MEMORANDUM

To: Design Review Board
From: Aoife Blake, Associate Planner
Date: November 24, 2020
File No.: DRV20-00187
Subject: **108TH OFFICE PROJECT
DESIGN RESPONSE CONFERENCE**

6700 108TH AVE OFFICE
DRV20-00187

1 LANDSCAPE SITE AND PLANTING PLAN
1" = 20'-0"

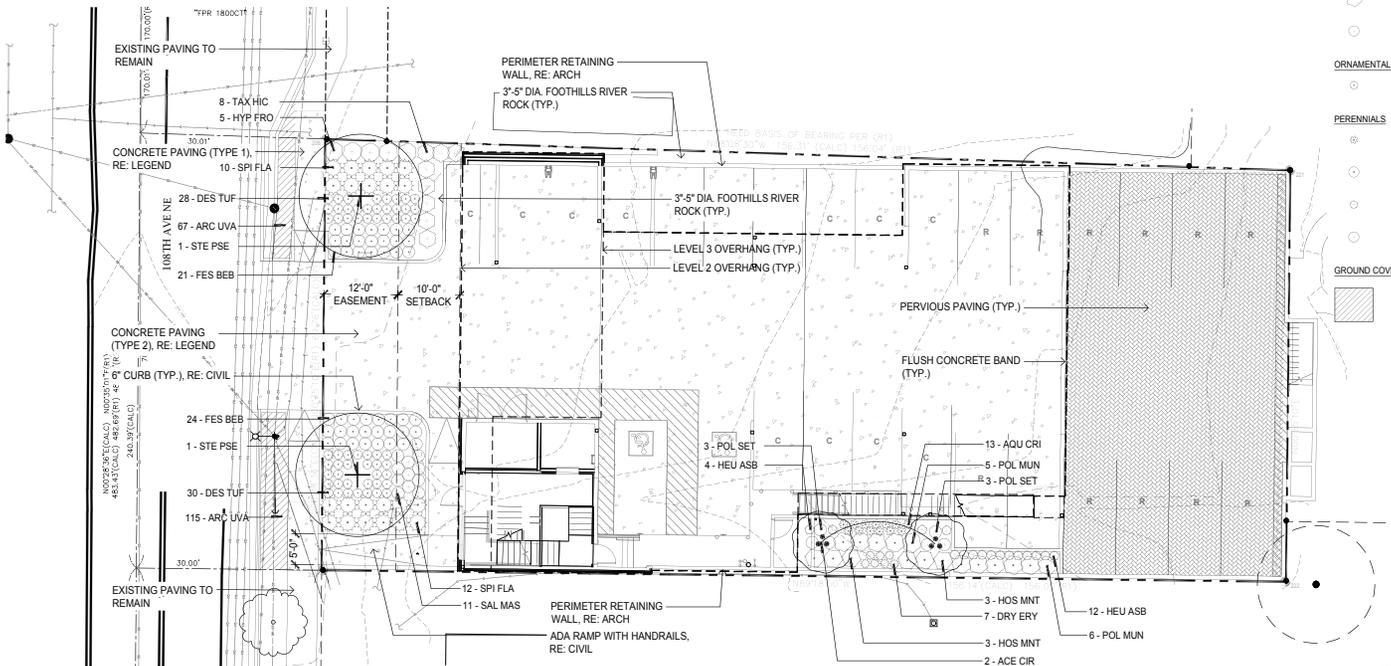
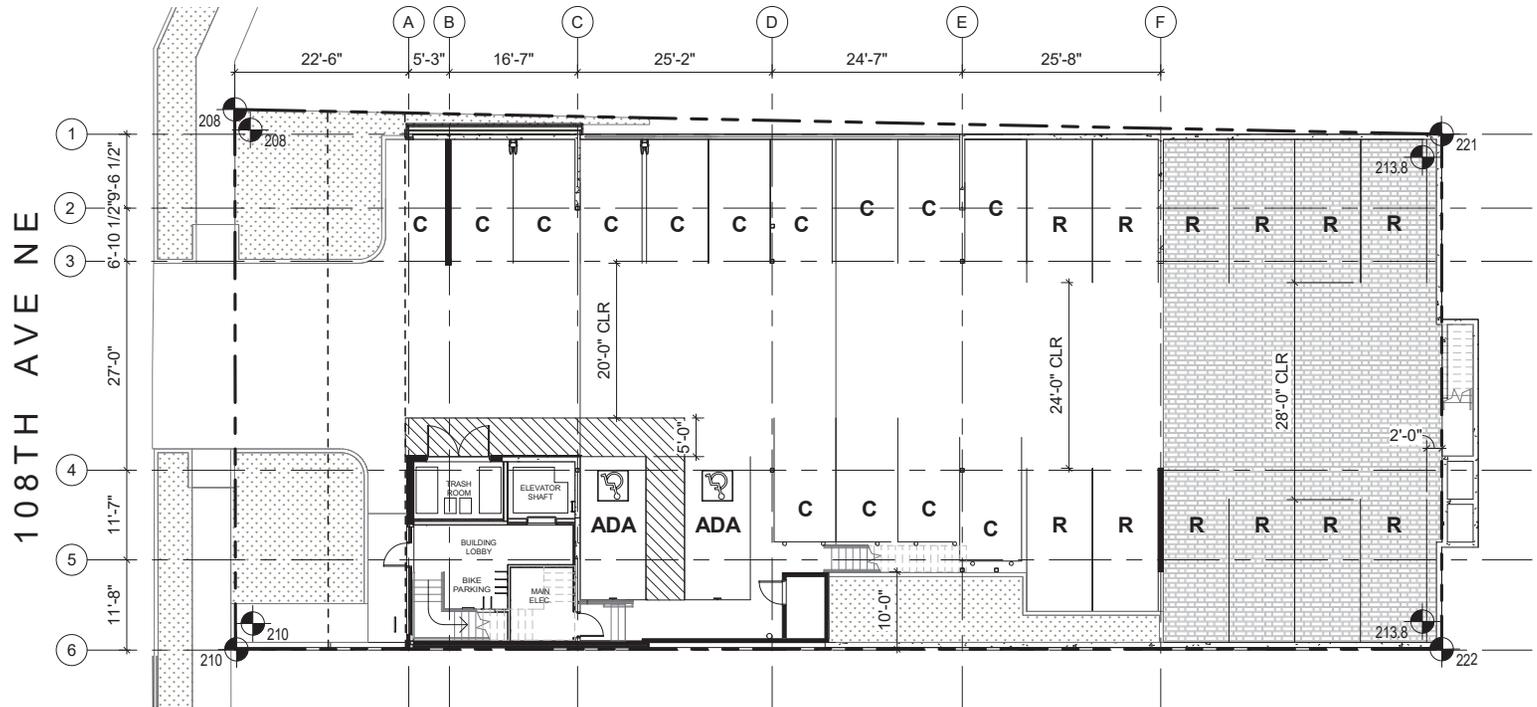
DRB Discussion: The DRB was satisfied with the proposed landscaping plan but expressed some concern about the screening of the compact stall in front of the building from the right-of-way and the placement of the landscaping with regards to future corridor improvements along 108th Avenue NE.

Staff Analysis: The landscape plan and species list has been revised to include a Hicks Yew shrub along the west side of the compact parking stall in front of the building (see sheets 13-14 & 19 of Attachment 2). This is intended to screen the compact stall from the right-of-way and is located outside of 12-foot easement for potential corridor improvements along 108th Avenue NE.

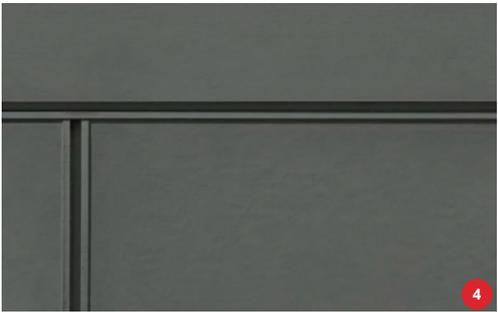
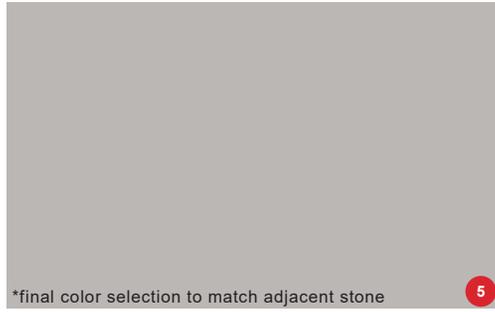
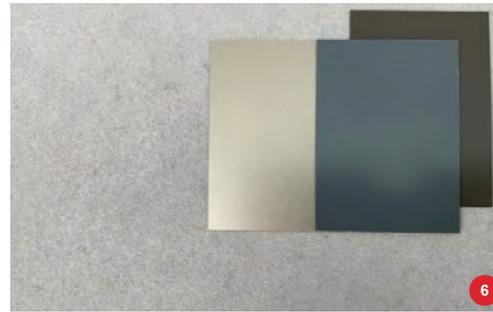
- **Front Façade:** The Board requested that the material and finishes of the following items be revised to provide a more cohesive look and feel to the front façade:
 - Fin wall separating the compact stall from the garage
 - Trash doors
 - Exterior lobby wall that returns into the garage

- Colors: The Board expressed concern regarding the darkness of the color palette, especially on the north façade with the use of the dark bronze metal panel. The Board suggested brightening up this facade by using lighter colors and/or lighting. *Staff Analysis: The revised plans show the metal panels along the north wall to be a metallic champagne color instead of dark bronze to brighten up this façade (see pages 18, 23-24, & 27-30 of Attachment 2). Samples of these colors have been included in this packet. Also, a number of light fixtures are proposed along the north façade to address this concern (see page 20 of Attachment 2).*

Staff Analysis: The revised plans show the fin wall and the exterior lobby wall to be treated with stone siding, the same siding that is proposed on the entry tower. The trash doors are proposed to be painted with a color that will match the stone siding (see pages 18-19, 22, 26-27, & 29-30 of Attachment 2).

*final color selection to match adjacent stone
TRASH DOOR -SHERWIN WILLIAMS
@ TRASH ROOM

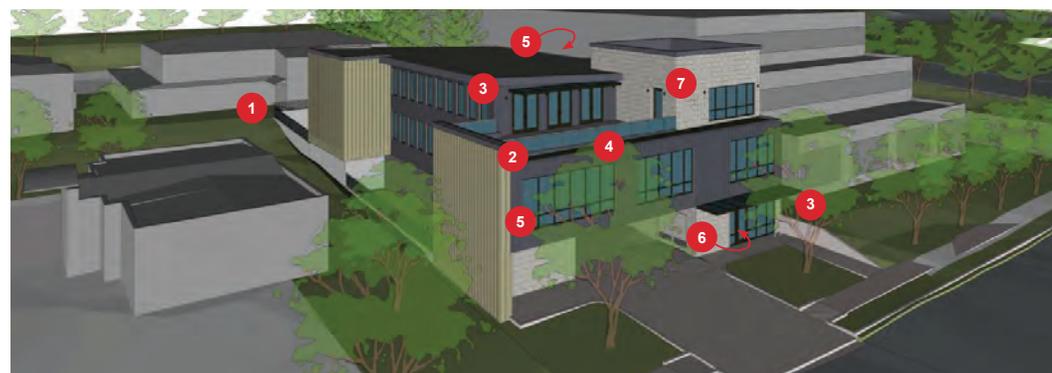
- **Glass Railing:** The Board expressed concern regarding potential glare issues from the glass railing along the deck perimeter.
Staff Analysis: The revised plans show the glass railing along the deck perimeter setback from the building edge by approximately 4.5 feet to address the concern of glare (see pages 8, 11, 17, 26-27, & 29- 30 of Attachment 2).
- **Metal/Hardi Panel Siding:** The Board expressed concern regarding the siding material and requested that the applicant provide more detail on how the material will be installed to create a pattern or otherwise.

A18-158 SOUTH ELEVATION
6700 108TH AVENUE, NE | KIRKLAND, WASHINGTON | 11/18/2020

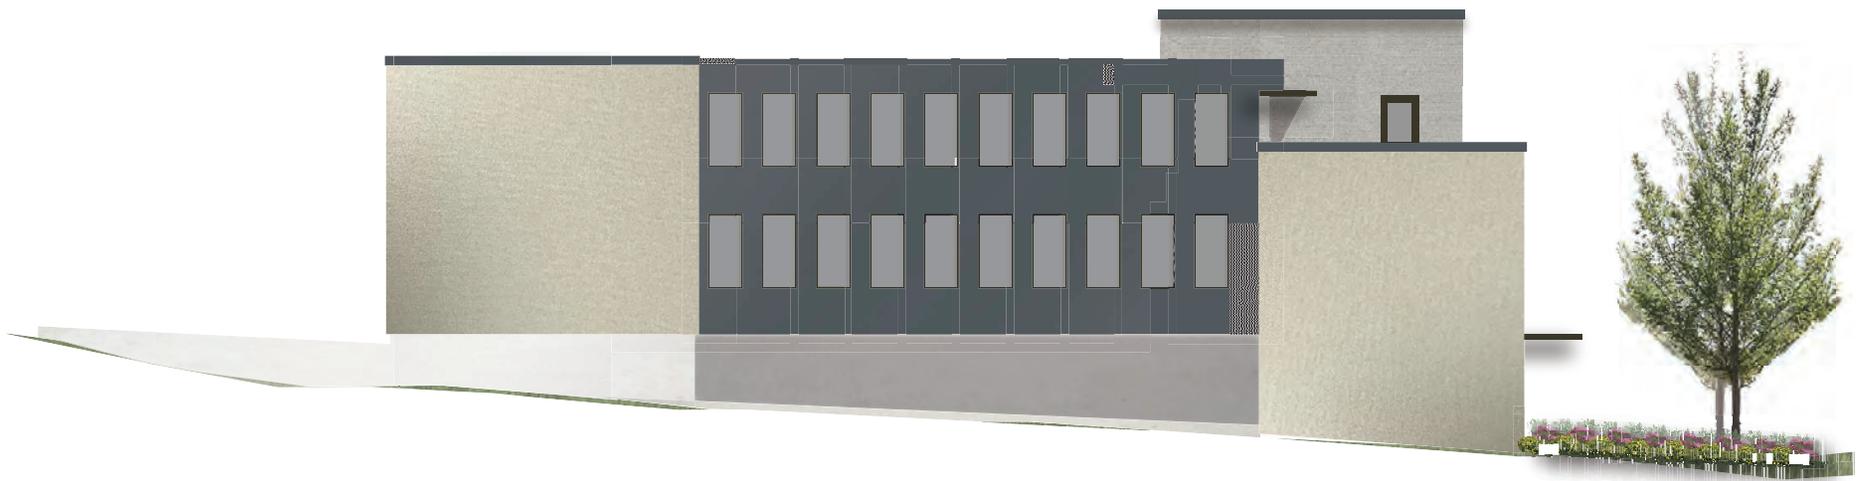
The DRB requested the applicant to utilize treatments along the south façade of the building to minimize the blank walls.

Staff Analysis: Pages 25, 26, & 29 of the plan set submitted by the applicant (see Attachment 2) illustrate how the applicant has treated the blank wall along the south façade. The plans show the slate colored 2" flex metal panel on the west façade return and continue approximately 12.5 feet along the south façade, breaking up appearance of the south wall of the entry tower.
